# Service Bulletin

Bulletin No.: 20-NA-080

**Subject:** Rear Outboard Heated Seats Inoperative, Possible Dead or Drained Battery

4889369

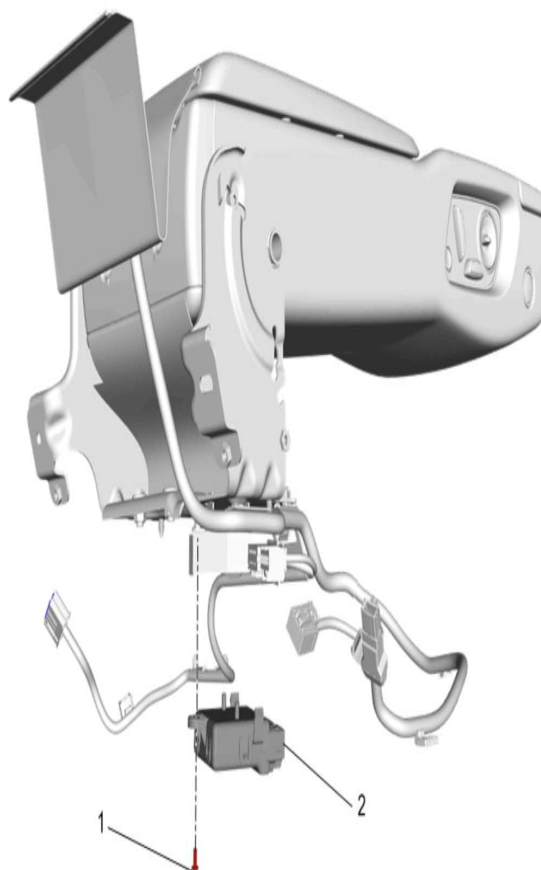
**Note:** The rear seat heater control module has been released separately for service. Do NOT replace the rear armrest assembly for this Condition.

Upon verifying this Condition, replace the rear seat heater control module (2). Refer to *Rear Seat Heater Control Module Replacement (Platinum)* in SI.
